UNITED STATES PATENT AND TRADEMARK OFFICE

APPLICATION NO.	FILING DATE	INVENTOR	ATTORNEY DOCKET NO.	CONFIRMATION NO.
10/727,306	12/03/2003	Douglas B. Wilson	114089.120	5202
23483	7590	03/30/2006	EXAMINER	
WILMER CUTLER PICKERING HALE AND DORR LLP 60 STATE STREET BOSTON, MA 02109			LUONG, VINH	
			ART UNIT	PAPER NUMBER
			3682

Office Action Summary	Application No. 10/727,306	Applicant(s) WILSON, DOUGLAS B.	
	Examiner Vinh T. Luong	Art Unit 3682

ATTACHMENT # 1

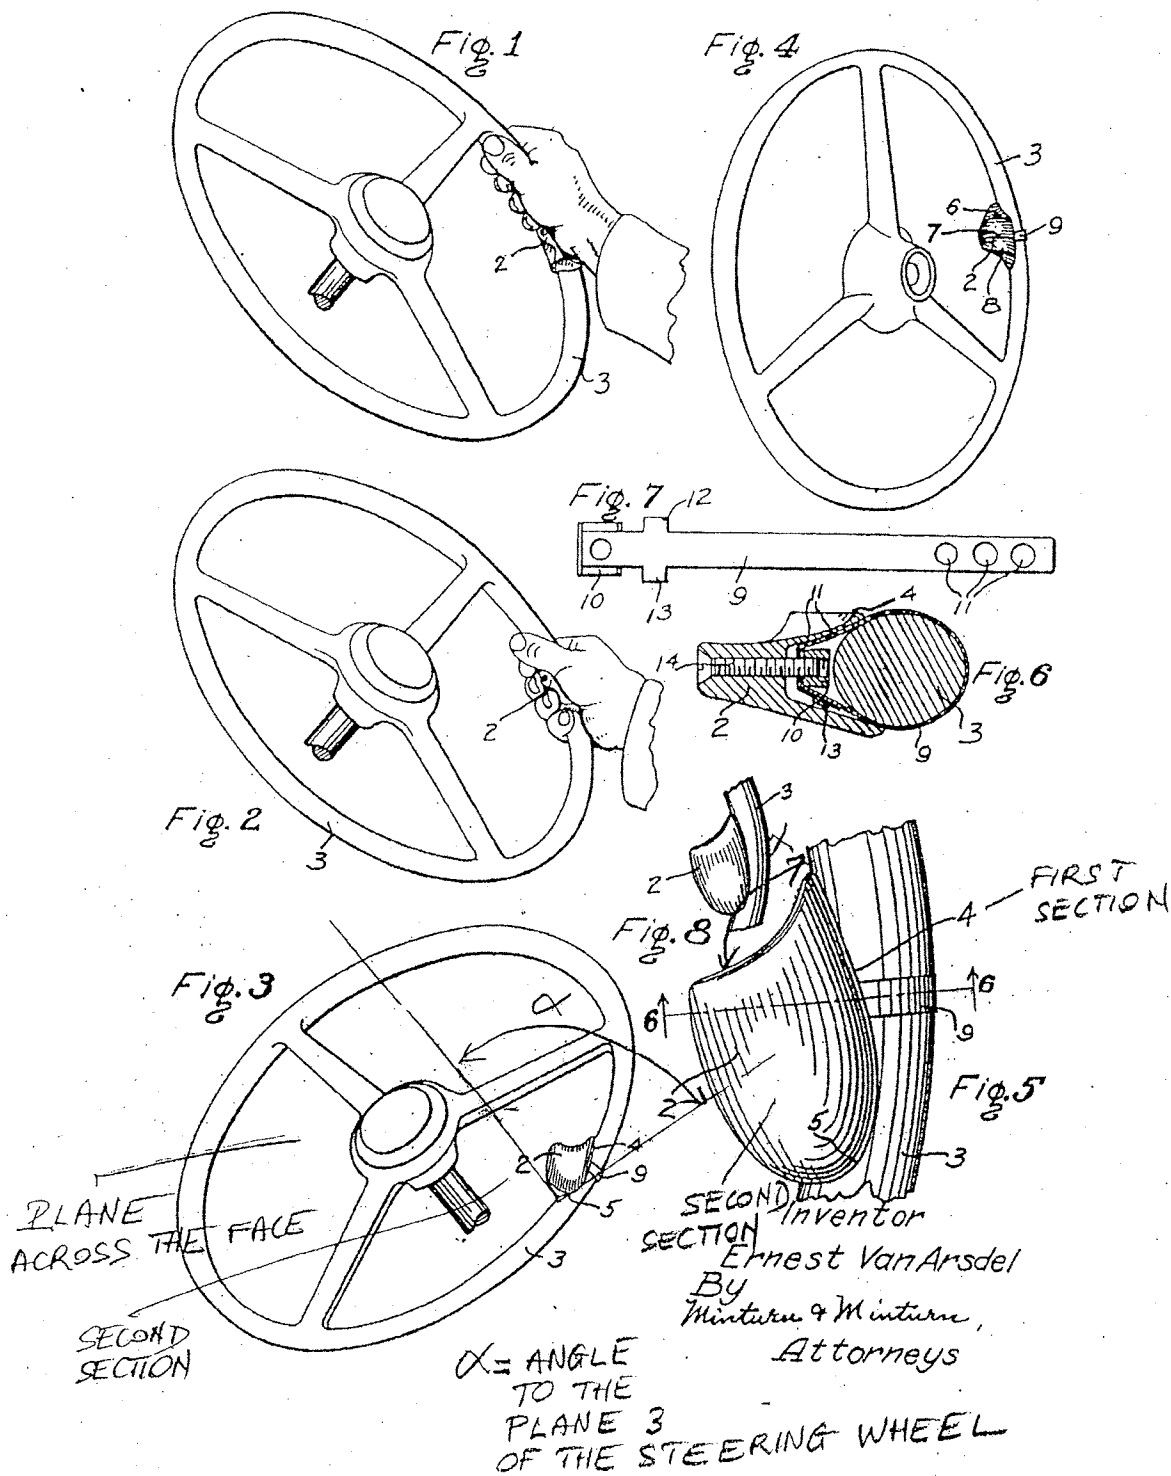
Regarding claim 14, Van Arsdell teaches a fatigue relieving/preventing apparatus associated with a steering wheel 3 for controlling a vehicle, comprising:

a first section 4 (i.e., a horizontal section) that connects to a peripheral portion of the steering wheel 3; and

a rigid, semi-rigid or flexible, or non-deformable second section 2 that connects to, and extends from the first section 4 at the peripheral portion of the steering wheel 3, the second section 2 extends from the first section 4 outward at an angle (see angle α in Figs. 3 and 5 of Attachment 1) to a plane (Att. 1) across a front face of the steering wheel 3, the second section 2 for supporting at least a portion of a vehicular operator's body when pressure from the portion of the vehicular operator's body on the second section 2 is less than the pressure for deforming the second section 2 out of interference with the vehicular operator's ability to operate the steering wheel 3, and deforming out of interference with the vehicular operator's ability to operate the steering wheel 3 when pressure from the portion of the vehicular operator's body on

the second section 2 is equal to or greater than the pressure for deforming the second section 2 out of interference with the vehicular operator's ability to operate the steering wheel 3.

The instant Office action only uses Laubach, Anson, and Van Arsdel. Each of these references teaches the second section disposed outward at an angle to the plane across the face of the steering wheel as seen in Attachments 1-3. Therefore, the elected claims 14-19, 24/14 and 27

ATTACHMENT # 2

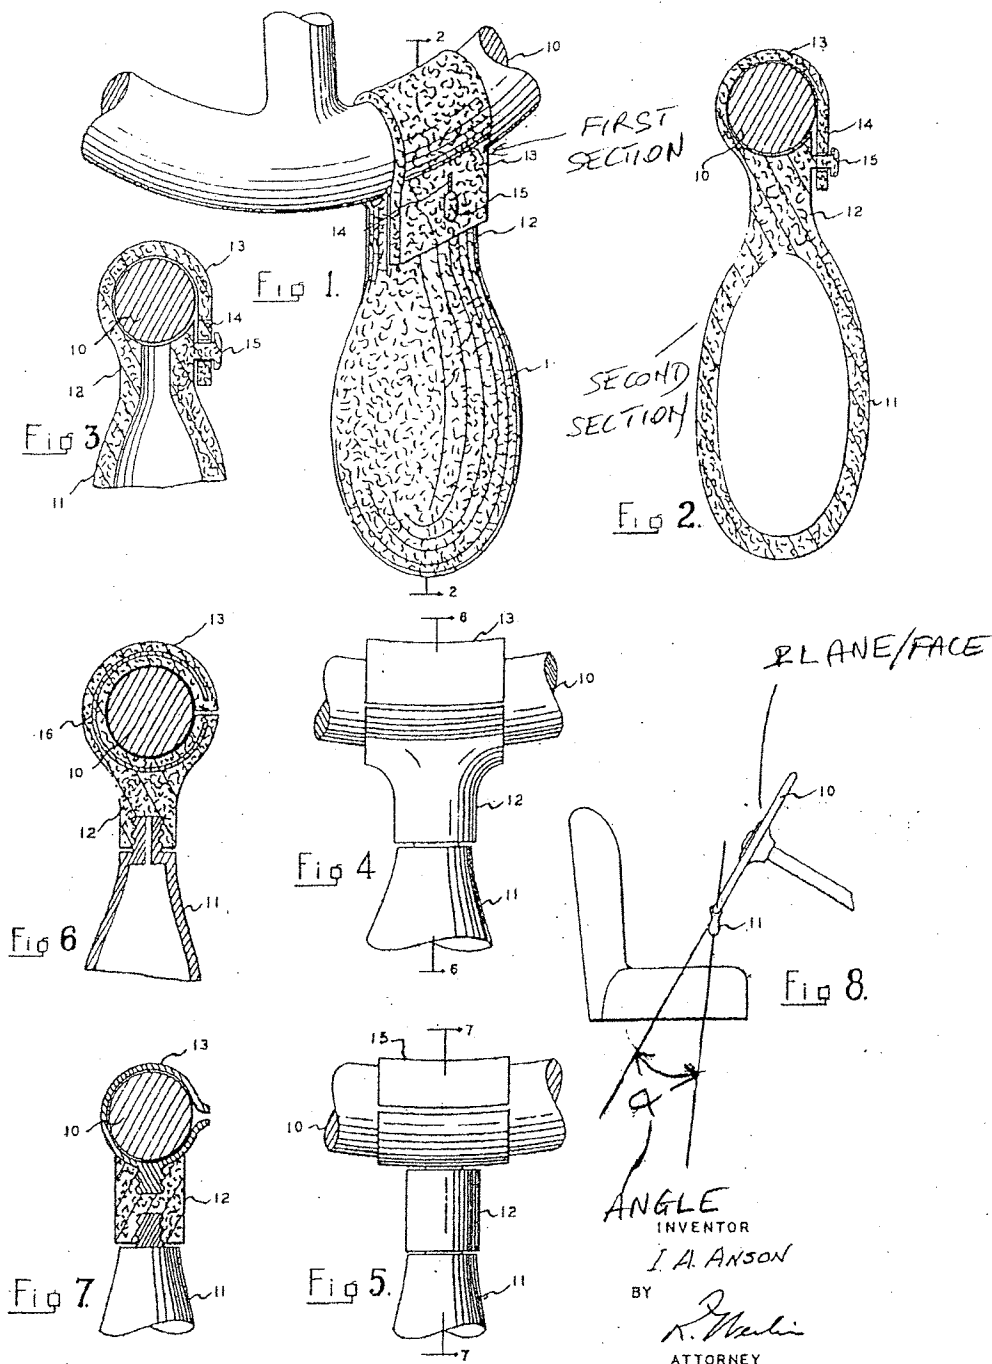
Regarding claim 14, Anson teaches a fatigue relieving/preventing apparatus associated with a steering wheel 10 for controlling a vehicle, comprising:

a first section 13 that connects to a peripheral portion of the steering wheel 10; and
a rigid, semi-rigid or flexible, or non-deformable second section 11 that connects to, and extends from the first section 13 at the peripheral portion of the steering wheel 10, the second section 11 extends from the first section 13 outward at an angle (see angle α in Fig. 8 of Attachment 2) to a plane (Att. 2) across a front face of the steering wheel 10, the second section 11 for supporting at least a portion of a vehicular operator's body when pressure from the portion of the vehicular operator's body on the second section 11 is less than the pressure for deforming the second section 11 out of interference with the vehicular operator's ability to operate the steering wheel 10, and deforming out of interference with the vehicular operator's ability to operate the steering wheel 10 when pressure from the portion of the vehicular operator's body on the second section 11 is equal to or greater than the pressure for deforming the second section 11 out of interference with the vehicular operator's ability to operate the steering wheel 10.

ATTACHMENT # 3

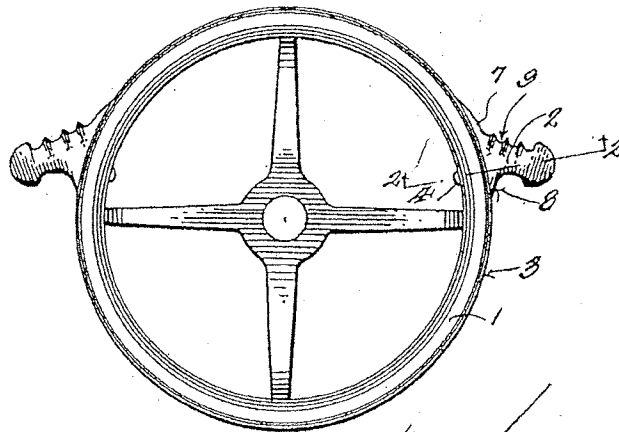
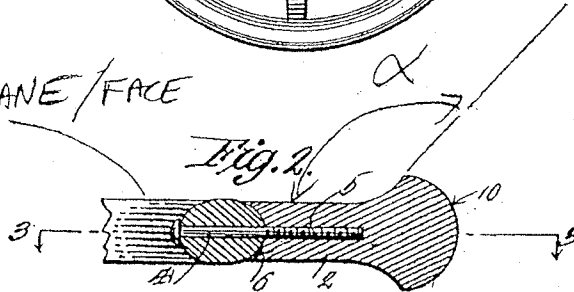
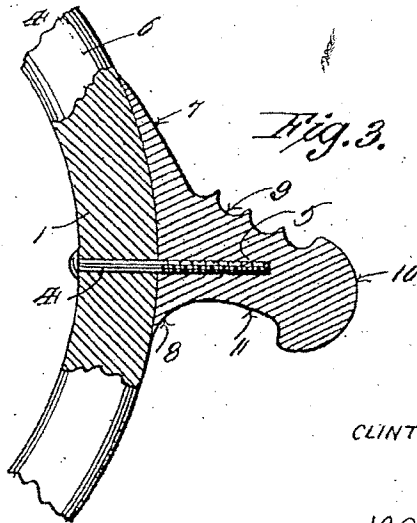
Regarding claim 14, Laubach teaches a fatigue relieving/preventing apparatus associated with a steering wheel 1 for controlling a vehicle, comprising:

- a first section 7, 8 that connects to a peripheral portion of the steering wheel 1; and
- a rigid, semi-rigid or flexible, or non-deformable second section 10 that connects to, and extends from the first section 7, 8 at the peripheral portion of the steering wheel 1, the second section 10 extends from the first section 7, 8 outward at an angle (see angle α in Fig. 2 of Attachment 3) to a plane (Att. 3) across a front face (Att. 3) of the steering wheel 1, the second section 10 for supporting at least a portion of a vehicular operator's body when pressure from the portion of the vehicular operator's body on the second section 10 is less than the pressure for deforming the second section 10 out of interference with the vehicular operator's ability to operate the steering wheel 1, and deforming out of interference with the vehicular operator's ability to operate the steering wheel 1 when pressure from the portion of the vehicular operator's

body on the second section 10 is equal to or greater than the pressure for deforming the second section 10 out of interference with the vehicular operator's ability to operate the steering wheel 1.

Regarding claim 18, the second section 10 includes at least two second sections (Fig. 1) that each connect to the first section 7, 8 at separate locations.
